Air Studios
Lyndhurst Hall,
Lyndhurst Road,
Hampstead,
London NW3 5NG

Structural and Ground Dynamics

Ref: AKS/3400/R1/i1

- To investigate structural and ground dynamics issues that could arise at Lyndhurst Hall, London NW3 5NG in relation to a proposed development comprising basements at an adjoining property known as 11 Rosslyn Hill, Hampstead.

- 8.10. Fig 8.10 shows proposed section GG¹⁷, edited to remove parts of Lyndhurst Hall in the background, to focus on the adjacency of new Basement and piling at closest approach.

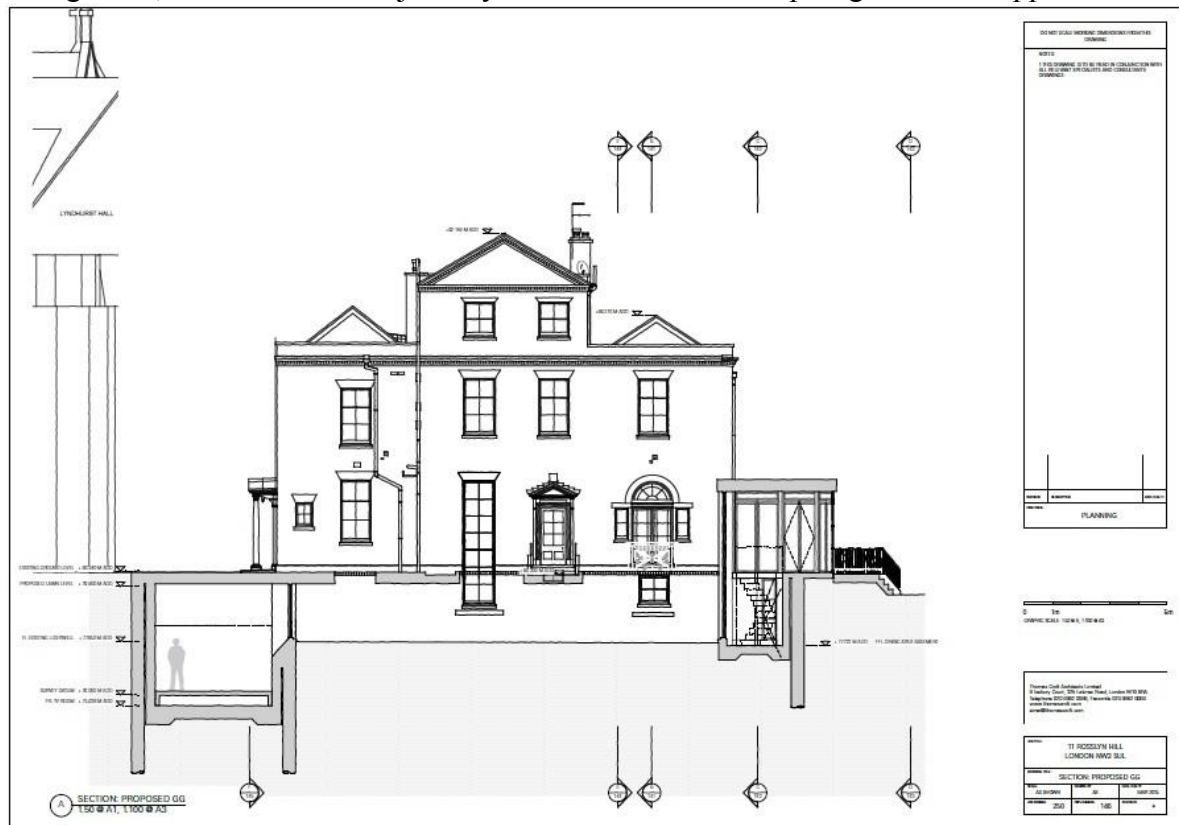
- 8.22. The lateral impedance of the Air Studios foundation in the long interface to the Cinema basement room (see fig 8.10), will change, and that may adversely influence performance of the triplex of floated studios, the significance of which remains to be seen, but can only be assessed by detailed investigation.

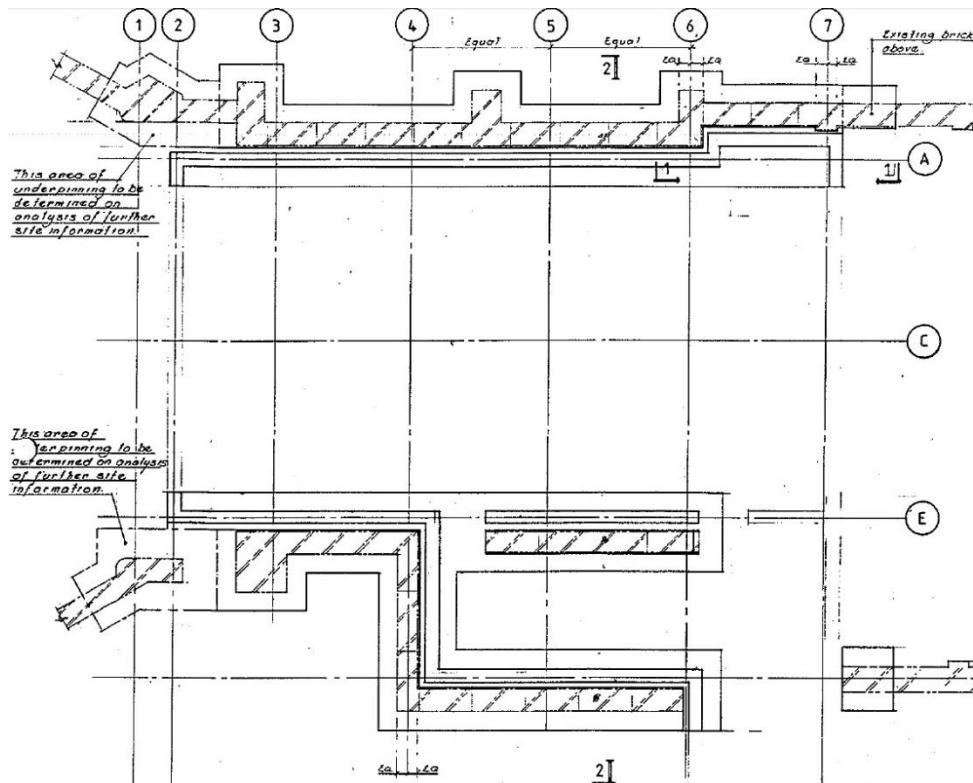
- 8.14. Fig. 8.14 shows an archive drawing indicating the extent and depth of underpin, which is yet to be confirmed, as there are no as-built record drawings. It is evident that the only Trial Pit (TP1) from the applicants SI²⁰ which attempted to discover foundations of the East wall happened to miss the section with the underpin, having been excavated to the right of grid 7.

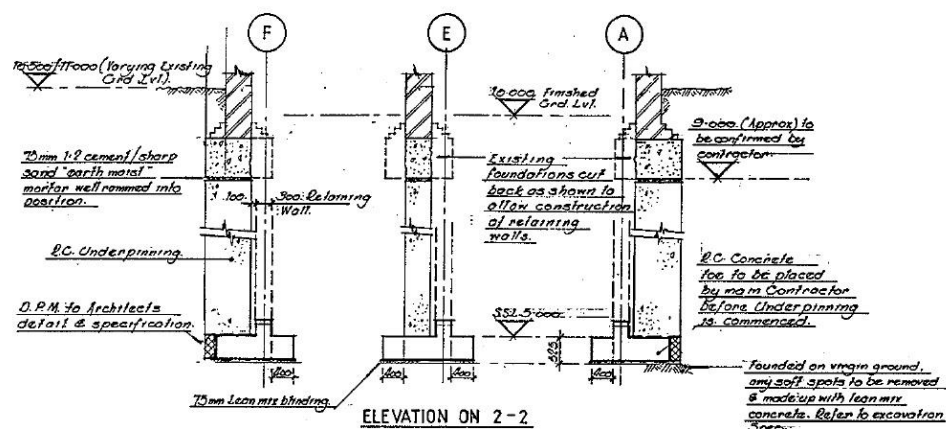
- 8.15. The section of the underpin shown in Fig 8.15, as with TP (1) of the SI shows that the wall on the East side adjoining the neighbours at 11 Rosslyn Hill, has corbelled brickwork and the concrete footing below also goes beyond, reducing the adjacency to the proposed piling and basement to the New Cinema Room. The depth of the underpin is indicative and reference to borehole information¹⁸ shows that it bears in the brown weathered clay.

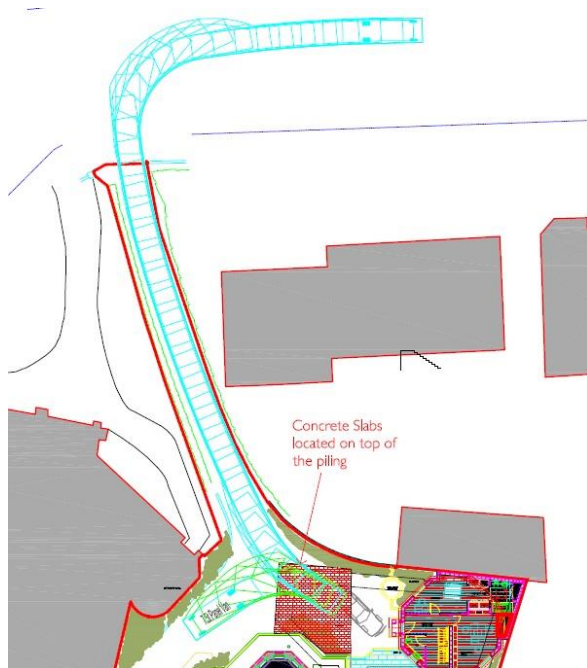
- 11.3. The swept path analysis for a small tipper truck and the 7.5 tonne van were given in the report by PMA²⁸, and a part of that diagram for the 7.5t Panel Van is reproduced in Fig 11.3. It shows such vehicles can turn on site. Longer vehicles will inevitably be necessary for such a project and it is unlikely that they could turn on site, and therefore implies a long reversing run on the access driveway, that not only creates a concern at the junction to the main road, but necessitate reversing alarms to be in operation for very much longer durations.
